Contract #: 04-0120F4Cty: SF/ALA Rte: 80 PM: 13.2/13.9File #: 69.25B**QUALITY ASSURANCE -- NON-CONFORMANCE REPORT****Location:** Shanghai, China**Report No:** NCR-000006**Prime Contractor:** American Bridge/Fluor Enterprises, a JV**Date:** 17-Sep-2007**Submitting Contractor:** Zhenhua Port Machinery Company, Ltd (ZPMC), Changxing Island**NCR #:** ZPMC-0005**Type of problem:**

NON-CONFORMANCE REPORT TRANSMITTAL

Subject: NCR No. ZPMC-0005

Reference Description: Repairs to longitudinal stiffener welds greater than 10% in length on the 77m Mock-up

Step 1 装配纵向筋

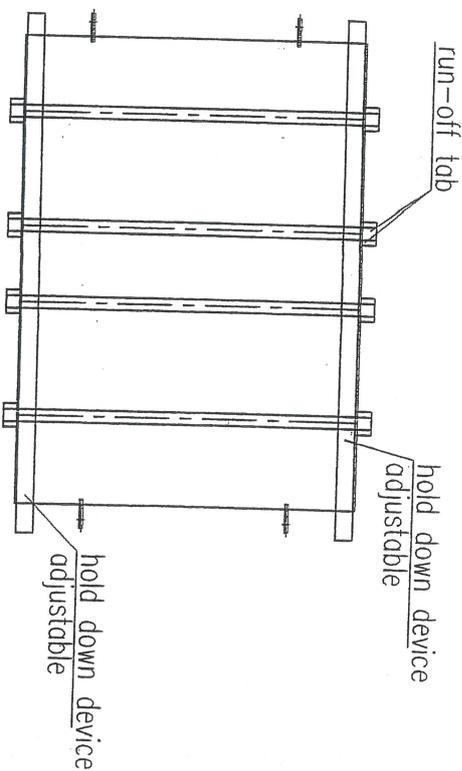
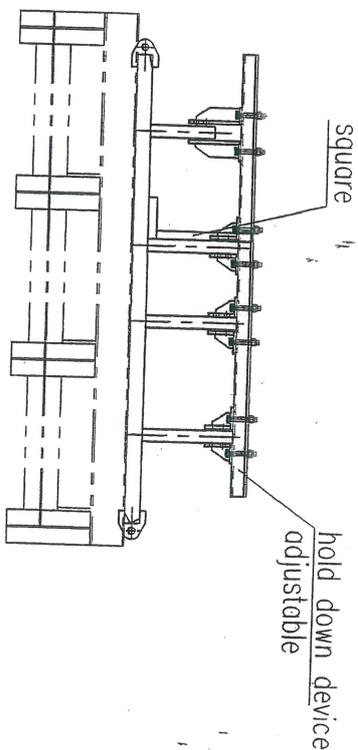
The Contractor has allowed the fabricator to proceed with making repairs to rejectable indications found in the complete joint penetration (CJP) welds which connect the longitudinal stiffeners to Skin Plates A and E of the 77m mock-up. These indications were found using Ultrasonic Testing (UT) at lengths greater than 10% of the cumulative length of the welds. These repairs are considered unsatisfactory to the Department regarding mock-up fabrication requirements. In addition, these repairs were made in manner that does not demonstrate a procedure that is repeatable in actual production.

Step 1. Fit up of Longitudinal Stiffener to Skin Plate.

1. 1. 在装配纵向筋之前,按照已批准的图纸要求将纵向筋加工到位,
1. 1. Machine approved weld detail bevels onto longitudinal stiffeners.
1. 2. 在面板上划好纵向筋的装配线.
1. 2. Lay out Skin plate and mark longitudinal stiffener positions.
1. 3. 在两端增加好可调卡码(如右图),安装并根据已批准的WPS的要求把纵向筋点焊固定在面板,检测其垂直度.
1. 3. Install adjustable holding down device, assemble and tack weld the longitudinal stiffeners to Skin plate inline with the parameters of the approved WPS and check the verticality to the Skin plate.
1. 4. 对所有尺寸进行检查.
1. 4. Check all the dimensions.
